**NOTICE TO BIDDERS
ADDENDUM #001**

TO THE BID FOR: B024-54 ARPA New Opportunity Kitchen Remodel

FOR: City of Meriden

NO	REVISIONS AND CLARIFICATIONS		REF. SPEC. SECTION	REF. DWG.	REF. BID SK
	Bidding Clarifications				
	<u>Division 1</u>				
1.01	Add specification section 013000 Administrative Requirements		13000		
	<u>Division 2</u>				
2.01	Clarification of demolition and configuration of closet at existing office.				BID SK-1
					BID SK-2
End of Addendum No. 1

BID SK-1

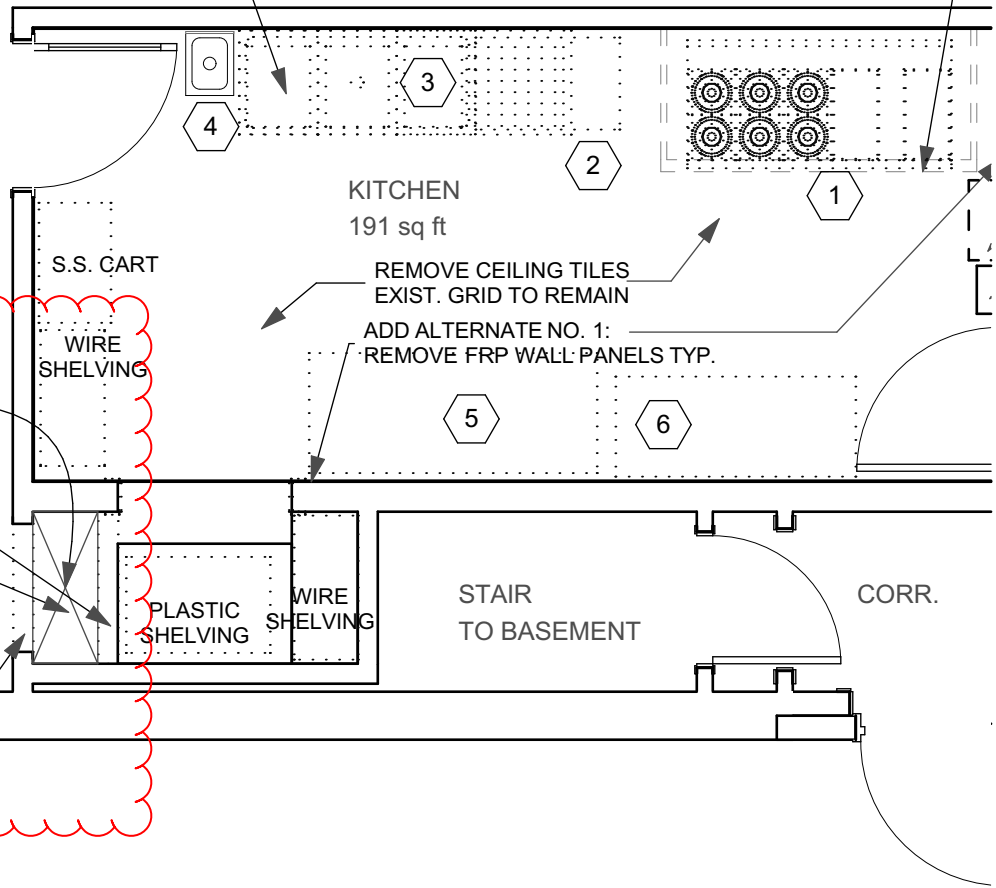
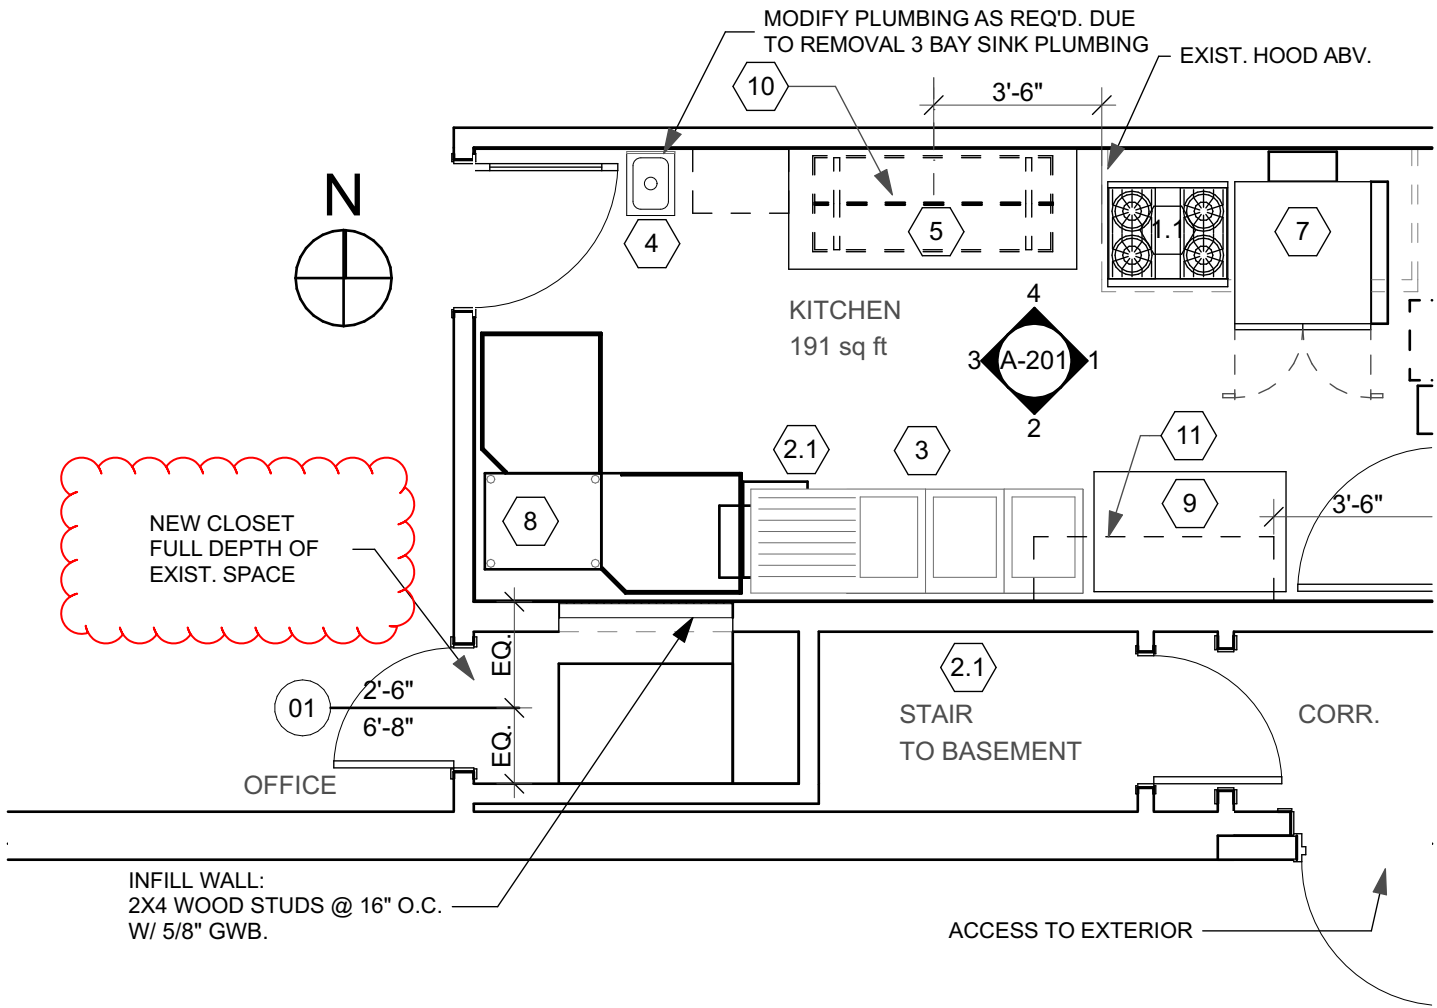
REMOVE PLUMBING ASSOCIATED
W/ 3 BAY SINK.
HAND SINK PLUMBING TO BE
MODIFIED AS REQ'D.

NOTE:
CONDITION BTWN.
EXIST. WALLS TBD.
PROCEED AS FOLLOWS:

1. REMOVE EXIST. WALL
2. REVIEW W/ ARCHITECT
CONDITION BTWN.
EXIST. WALLS
3. CUT IN OPENING FOR
NEW DOOR

REMOVE CEILING TILES
EXIST. GRID TO REMAIN
ADD ALTERNATE NO. 1:
REMOVE FRP WALL PANELS TYP.
